PLANNING COMMISSION AGENDA
MONDAY, MAY 23, 2022
CITY HALL at 7:00 PM

To:	Spring Lake Park Planning Commission	From:	Lauren Walburg, Stantec
	City of Spring Lake Park		
File:	Take 5 Car Wash 8301 University Ave NE Applicant: Rebecca McAllister, Boing US Holdco, Inc. Owners: Muchtar and Fatima Sajady	Date:	May 23, 2022

Re: Variance, Conditional Use Permit, Site Plan Review - Take 5 Car Wash, 8301 University Ave NE

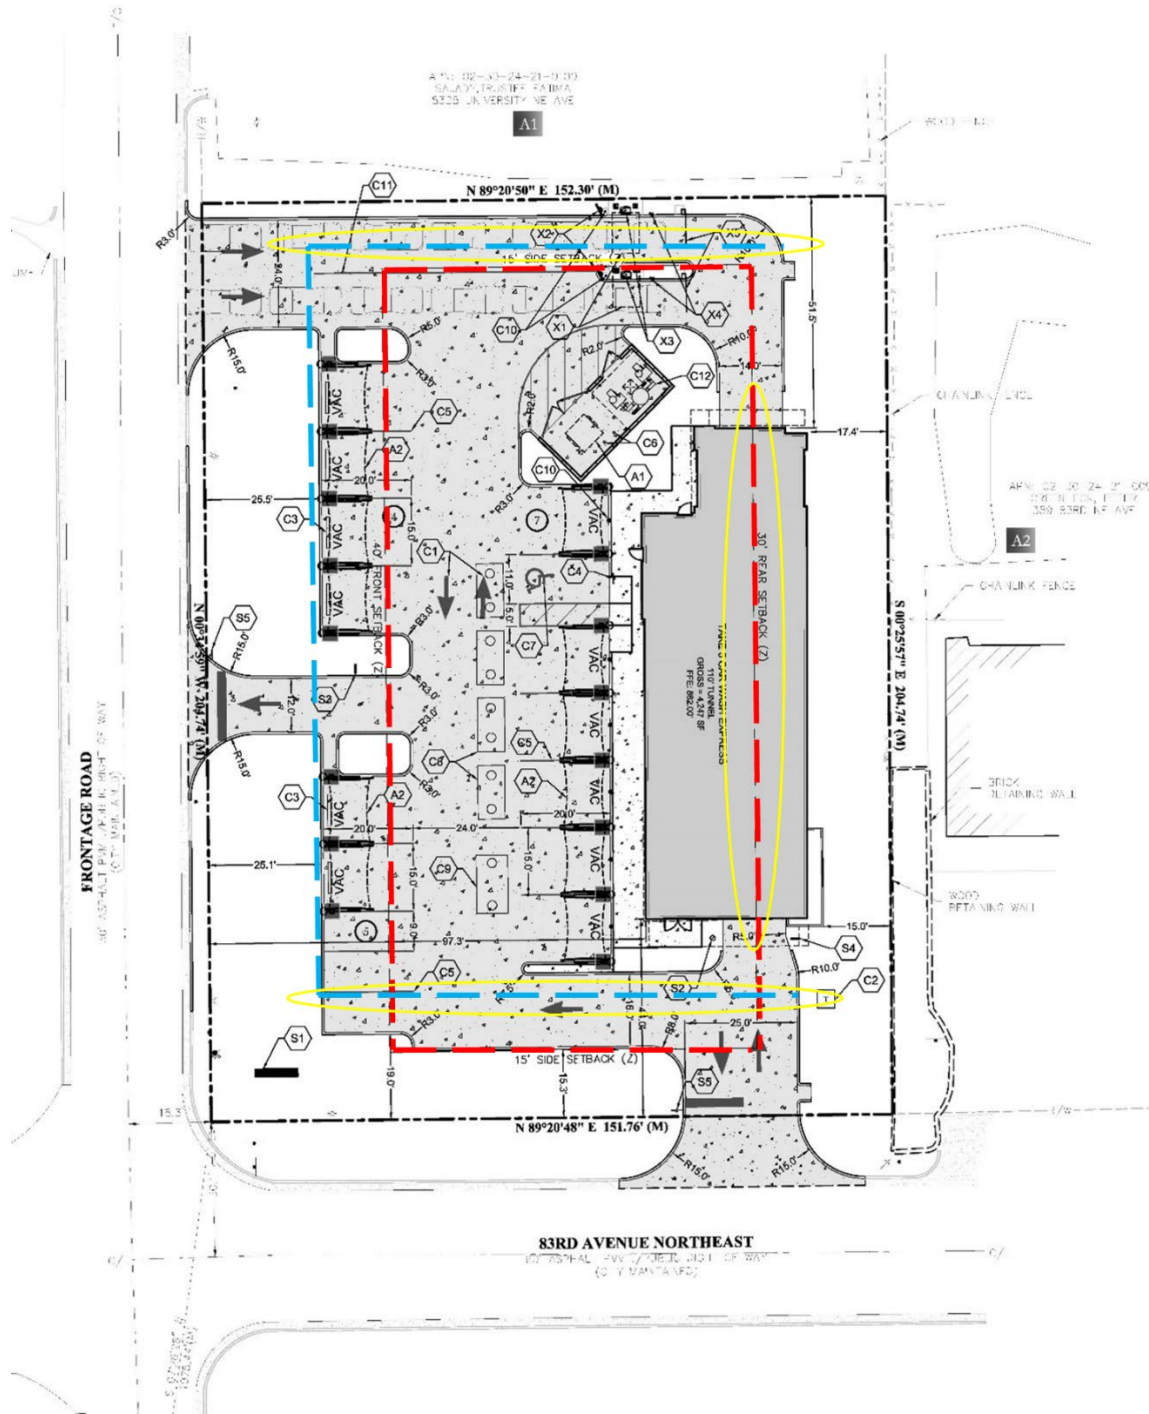
As mentioned, the site plan as submitted does not meet all setback requirements in the C-2 zoning district, therefore requiring a variance which the applicant has applied for along with this CUP application. The setbacks that do not meet requirements are described below and shown circled in yellow in the diagram on the next page.

1. Corner side yard *parking setback* as shown is 15 feet, code requirement is 25 feet (south side of property adjacent to 83rd Ave NE)
2. Side yard *parking setback* as shown is about 3 feet, code requirement is 10 feet (north side of property)
3. Rear yard *building setback* as shown is 15 feet, code requirement is 30 feet (east side of property adjacent to Nelson Cheese and Deli).

The parking setbacks as proposed are a significant improvement to the existing parking lot setbacks, which encroach on the neighboring property to the north, and extend nearly to the property line at the south end of the property. While the application requires a variance to comply with the zoning code required setbacks, staff is in favor of granting this variance as an improvement to existing conditions.

SHEET TITLE:
SITE PLAN

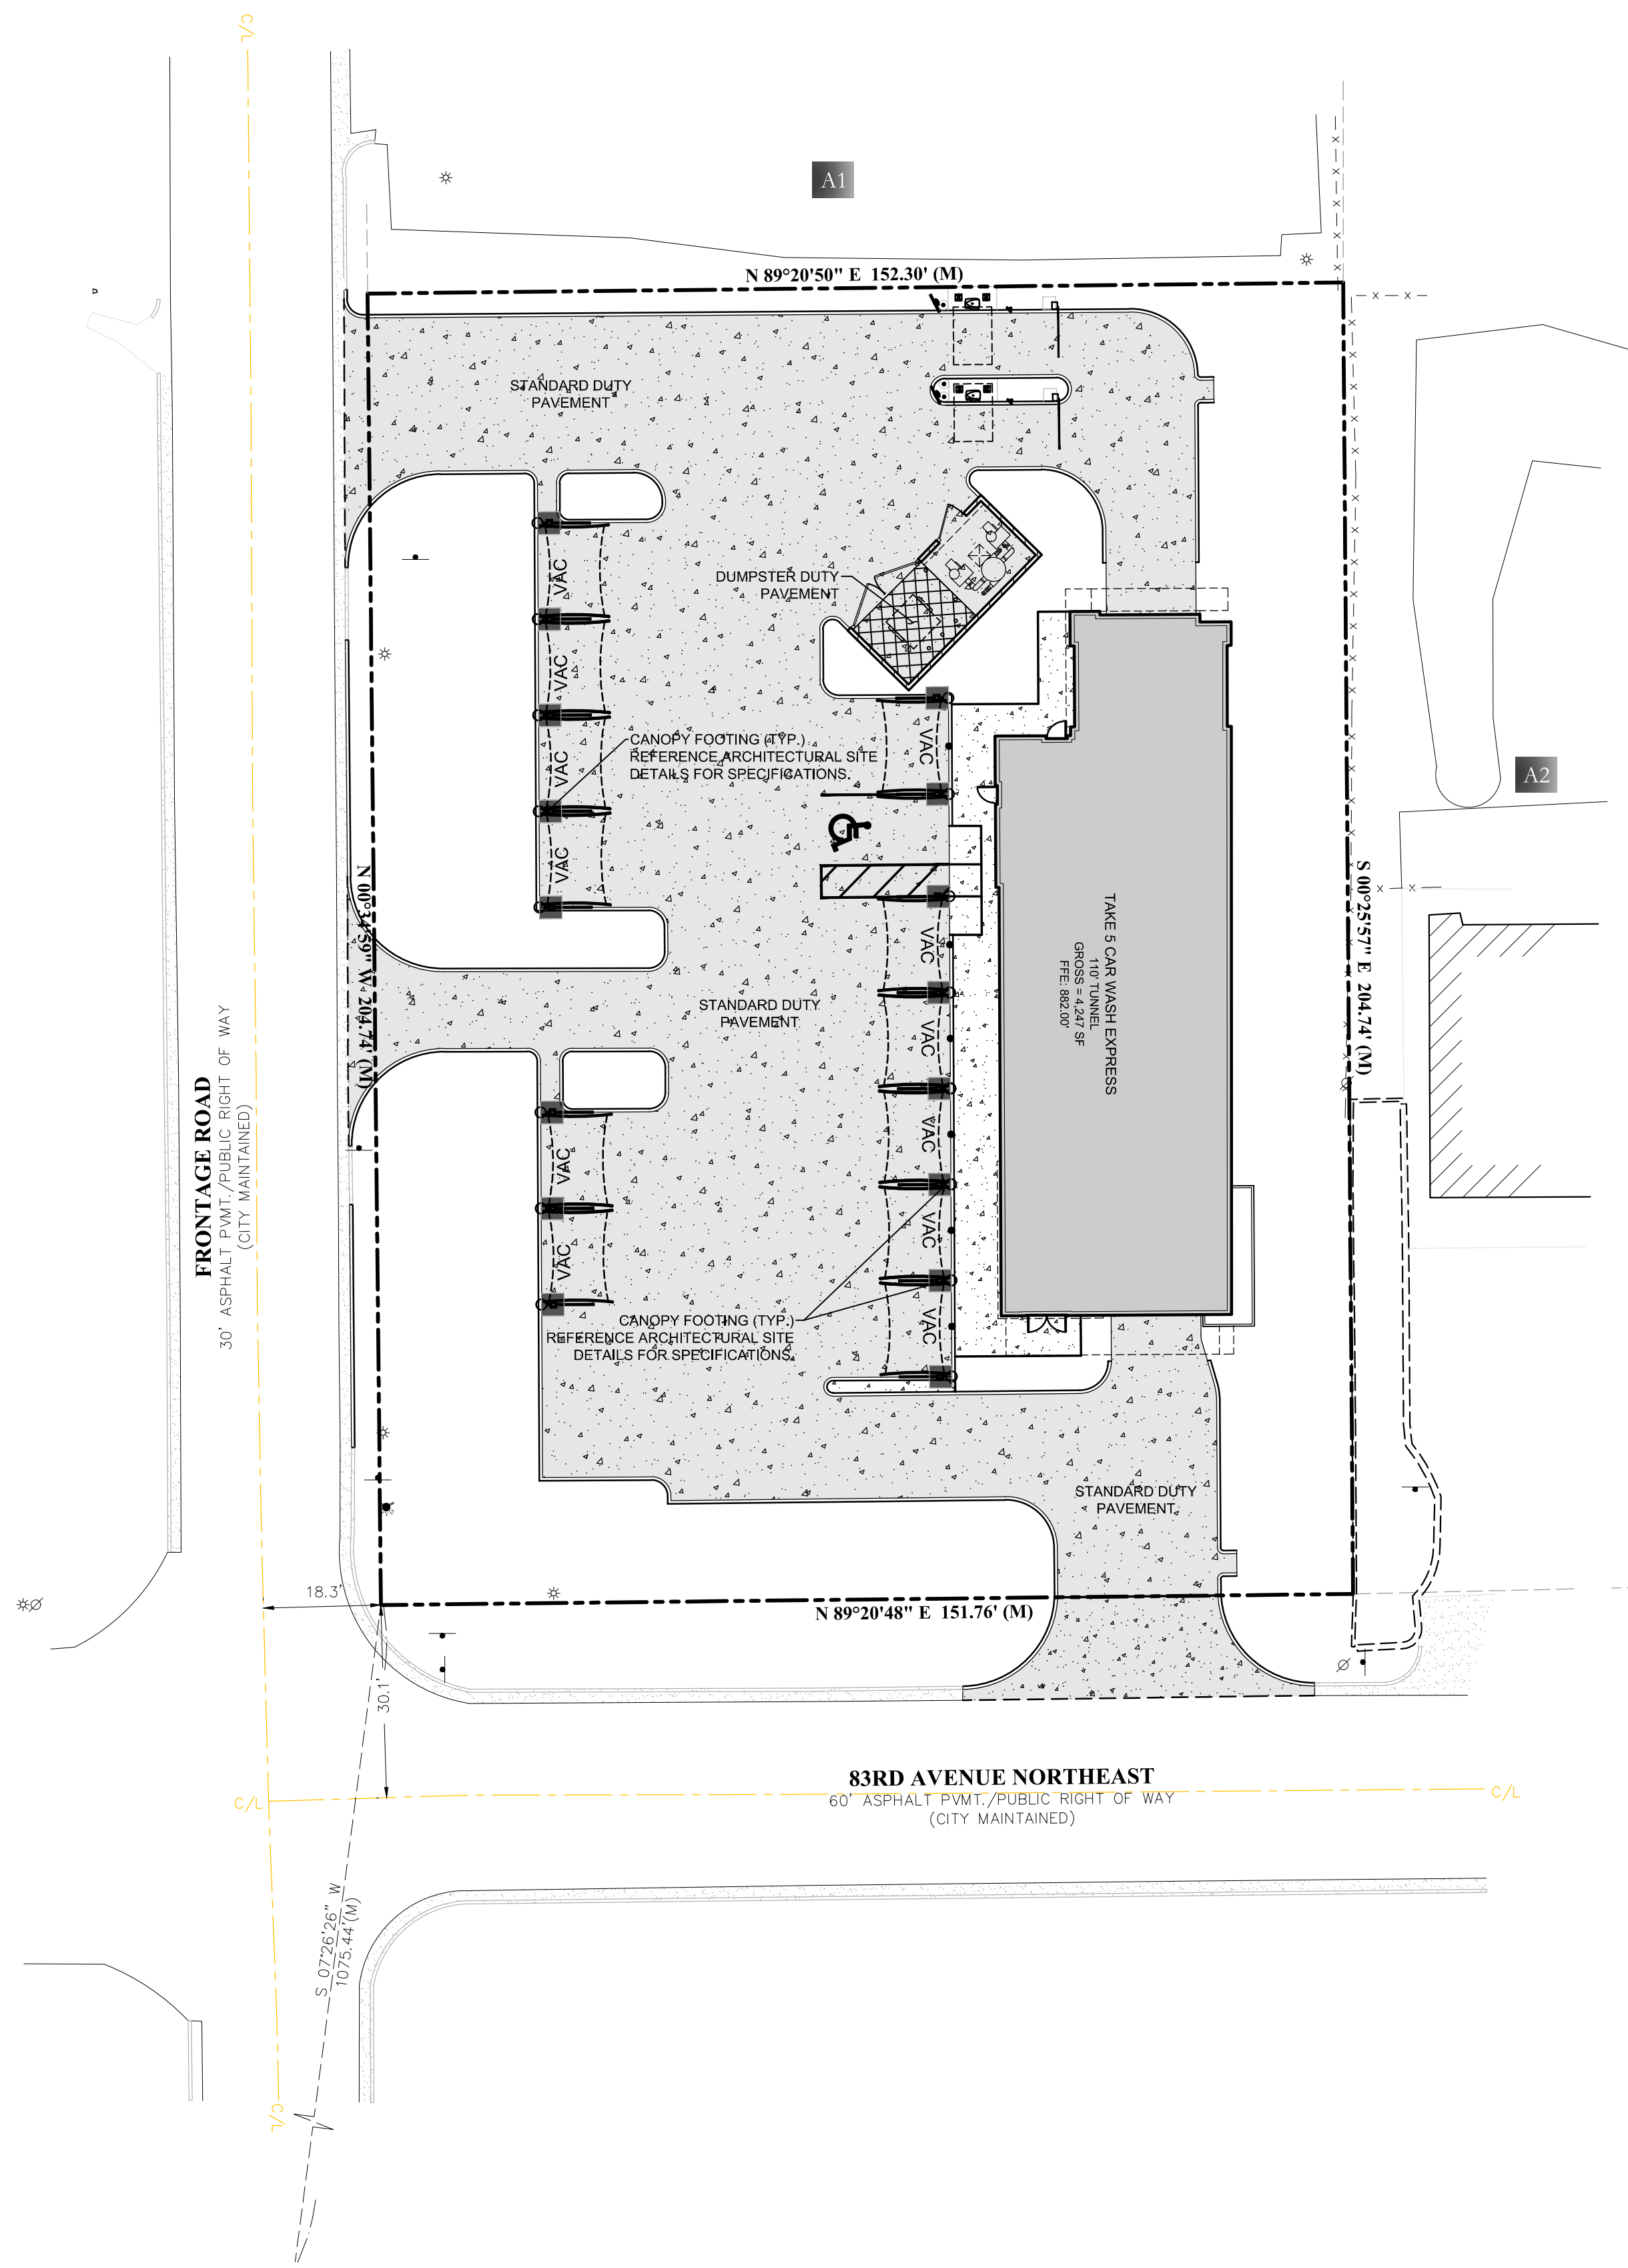
An issue with any drive-through type facility is adequate stacking and making sure that cars waiting in line don't interfere with cars on the adjacent street. The site plan submitted by the applicants shows 12 cars waiting in the pay station lines, and an additional 2 cars between the pay stations and the tunnel. This may be adequate, based on the submitted traffic study and analysis. Should traffic and queuing become an issue, there needs to be clear signage so that stacking onto the road is not allowed. The site plan currently shows stop signs at all exit points to ensure safe exiting of the site. If traffic and queuing becomes an issue, the City Engineer has included a condition that additional signage be installed to indicate queuing on University Ave Frontage road is prohibited.

There site plan shows 16 parking spaces in front of the building in the parking/vacuum area, including 3 standard parking spaces, 12 vacuum spaces and 1 handicap space. This would serve customers and staff for the facility. Spring Lake Park's parking standards require 10 spaces per lane in a commercial car wash. This facility may be different than what was imagined for a "commercial car wash" when the code was written. We recommend relying on the applicants' experience with their facilities to propose adequate parking.

- 10) Grading. Site plan shall be revised to create high points in all 3 driveways to prevent site drainage from draining directly on to 83rd Ave. NE or University Service Drive. Utilize proposed green space(s) for stormwater management.

ISSUED DATE: 03-07-22
 PROJ. #: 21-429E
 DRAWN BY: KB
 DATUM: SEE SURVEY
 REF. #: SEE SURVEY
 F.B. & PG.: SEE SURVEY
 SHEET TITLE:
UTILITY PLAN
 SHEET
C-6
 DWG. NO.

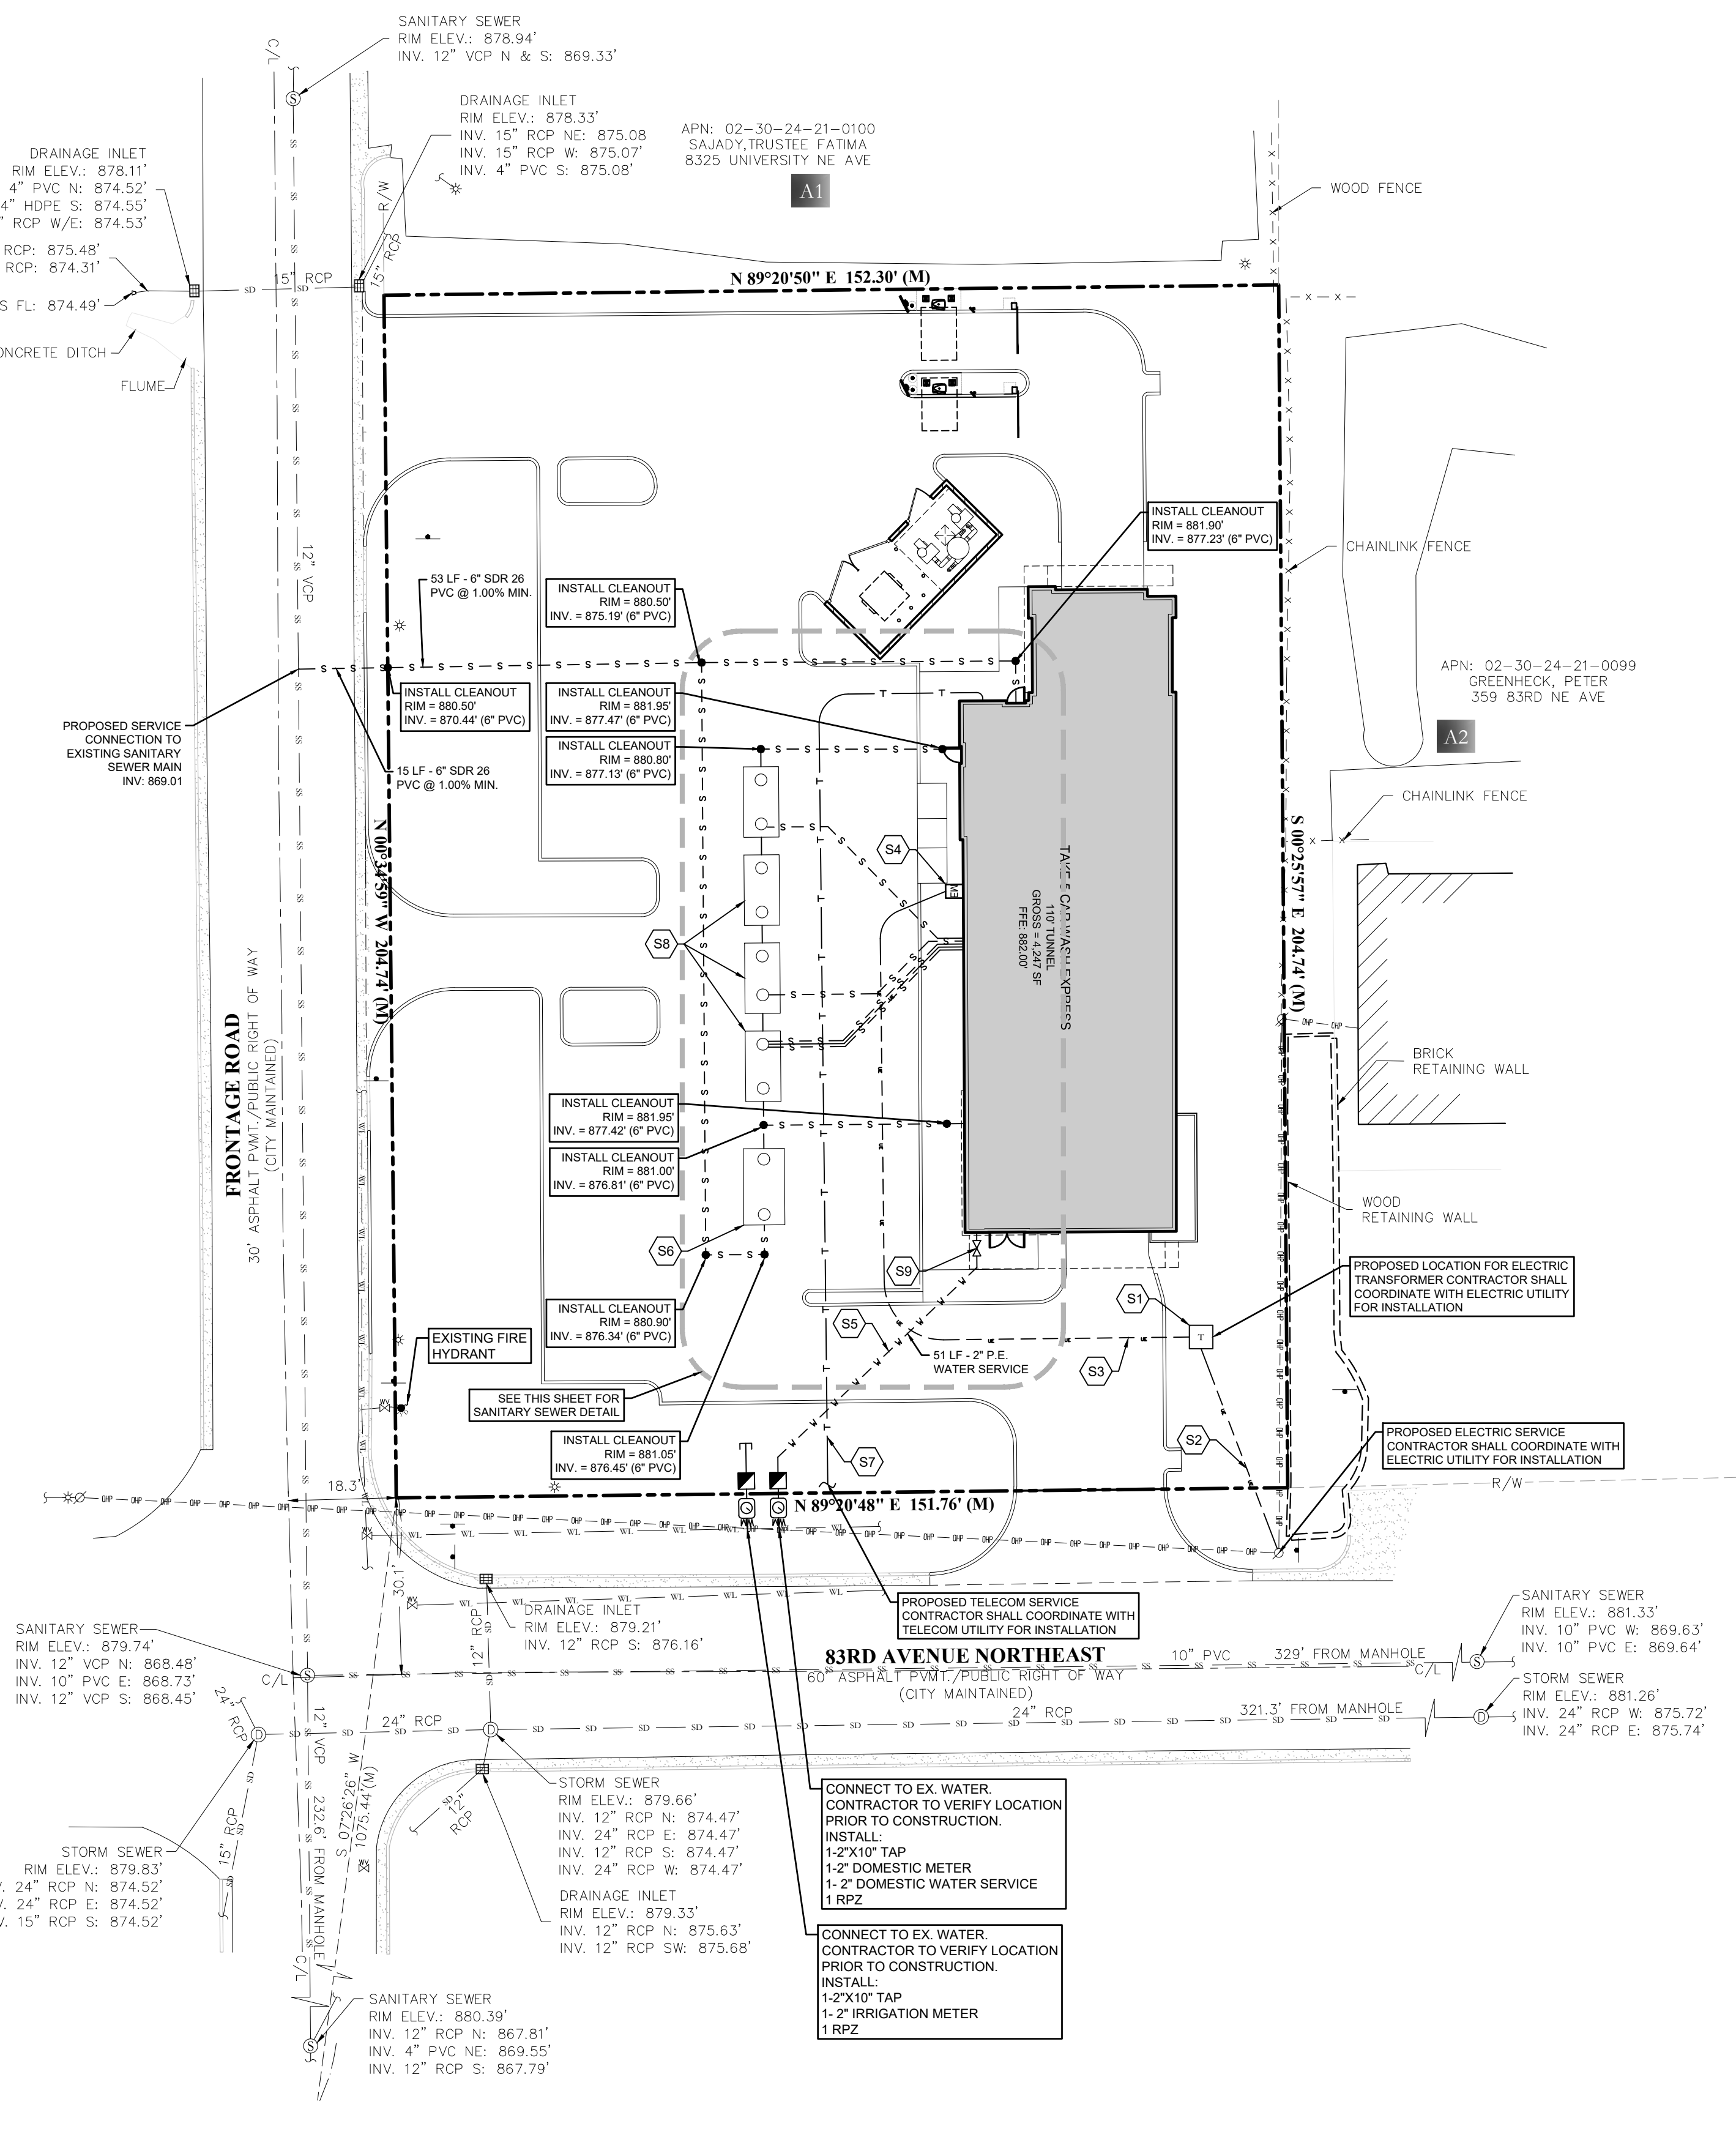
- 14) Sanitary Sewer. Show existing sanitary sewer service(s) on utility plan. Re-use an existing sewer line for site service (no new connection). Locate and plug any existing sewer service that is not to be used.

- 15) Water Works. Show existing water service(s) on utility plan. Locate and plug any existing water service that will not be reused (plug at the main).
